THE DOW CHEMICAL COMPANY

December 2, 1963

William O. Miller
Isotopes Branch
Division of Licensing and Regulation
U. S. Atomic Energy Commission
Washington 25, D. C.

This letter is to supply additional information requested in your letter of August 8, 1963, in response to our application for a radiography license dated July 19, 1963.

CONTAINER FOR COBALT 60 SOURCE NO. 36085-1

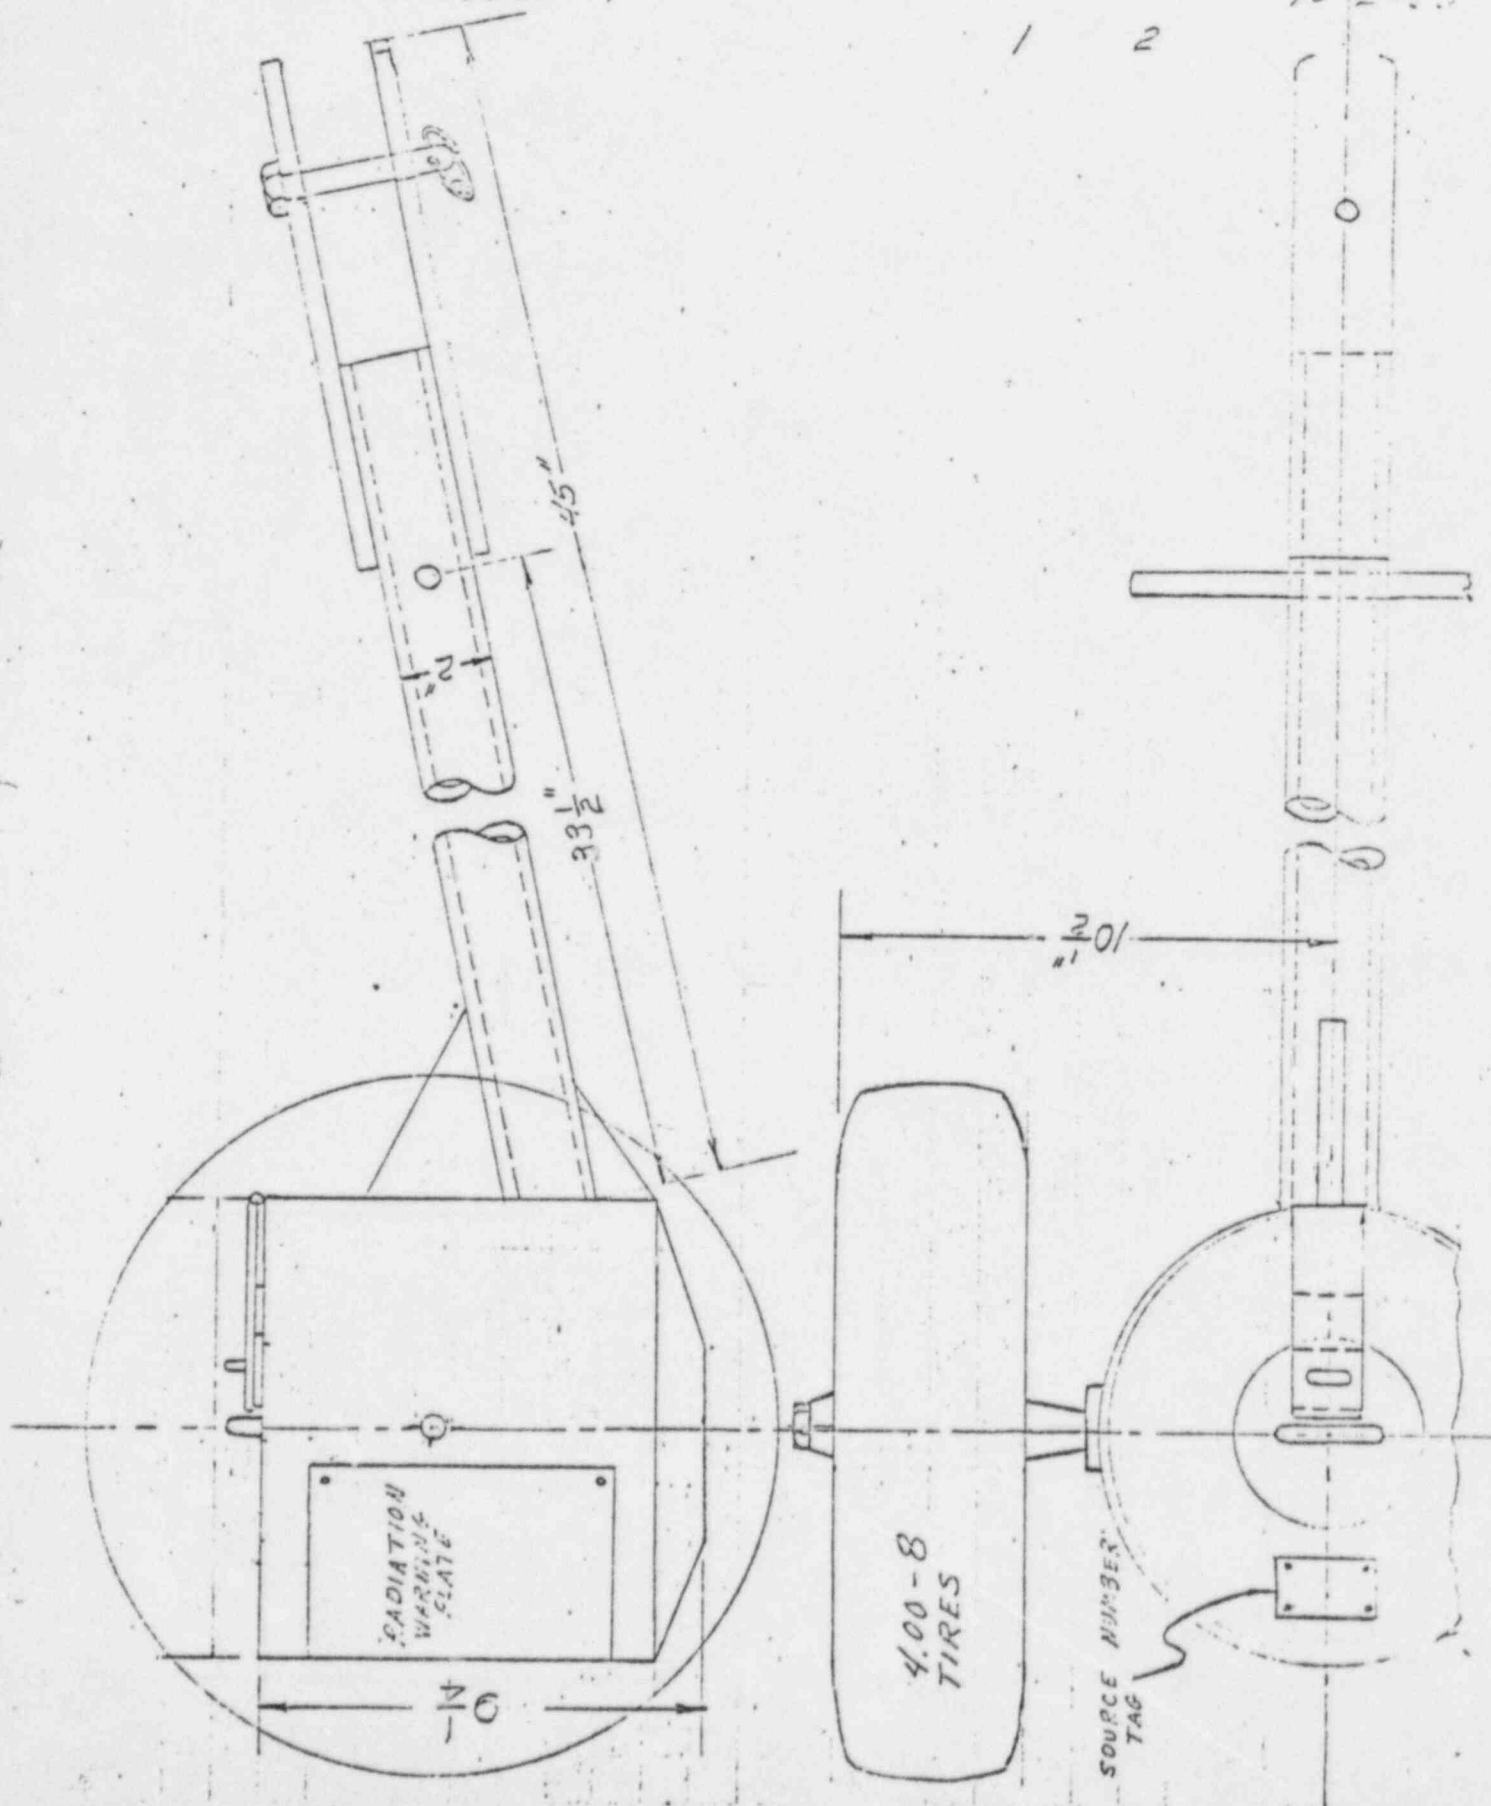
2. Item 5-B. The model number of the Tracerlab storage container is E-318.
3. The design of the Dow-built storage container is included as Attachment A. The radiation profiles for the container are given in Attachment B.
